Access Compliance Report

Public Rights-of-Way

Intersection ID: 10031975	Main Street: MONROE_RD	Cross Street: N/A	Location: SW
ADA ID: 255B70EC062D	Ramp Type: Perp	Initial Pass/Fail: Fail	Overall Compliance: No
			Severity Score: 21.25

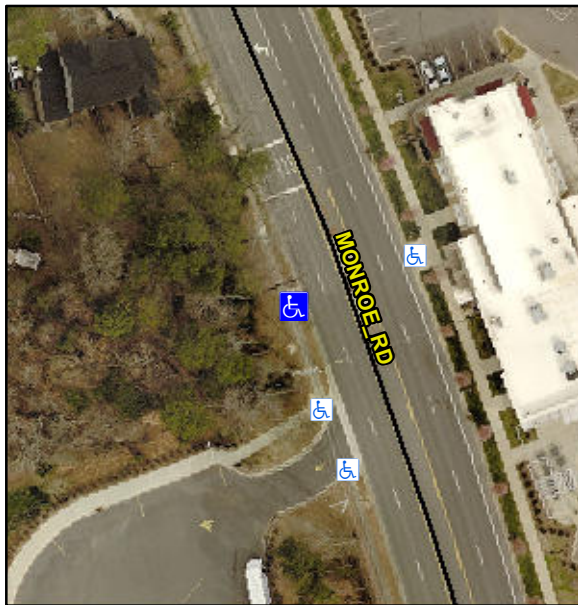
Not Found, R304.5.1, R304.2.2

Compliance	Description	Data	Compliance	Description	Data
N/A	Ramp Length (in)	53.0	No	Ramp Slope (%)	9.8
No	Ramp Width (in)	47.0	Yes	Ramp XSlope (%)	1.2
N/A	Flare Type LT	N/A	N/A	Flare Type RT	N/A
N/A	Flare Slope LT (%)	N/A	N/A	Flare Slope RT (%)	N/A
N/A	Flare Traversable LT?	N/A	N/A	Flare Traversable RT?	N/A
N/A	Landing Length (in)	N/A	N/A	DWS Provided?	N/A
N/A	Landing Width (in)	N/A	N/A	DWS Contrast?	N/A
N/A	Landing Slope (%)	N/A	N/A	DWS Length (in)	N/A
N/A	Landing X Slope (%)	N/A	N/A	DWS Full Width?	N/A
N/A	Landing Curb? (Y/N)	N/A	N/A	DWS Offset (in)	N/A
N/A	Shared Landing?	N/A			
N/A	Gutter Ponding?	N/A	N/A	Gutter Slope (%)	N/A
N/A	Gutter Lip Ht (in)	N/A	N/A	Gutter X Slope (%)	N/A
N/A	Painted X Walk1?	No	N/A	Painted X Walk2?	N/A
	X Walk 1 Direction	To NE		X Walk 2 Direction	N/A
N/A	X Walk 1 Width (in)	N/A	N/A	X Walk 2 Width (in)	N/A
	X Walk 1 Slope (%)	5.5		X Walk 2 Slope (%)	N/A
	X Walk 1 X Slope (%)	1.5		X Walk 2 X Slope (%)	N/A

Remove & Replace Entire Ramp.
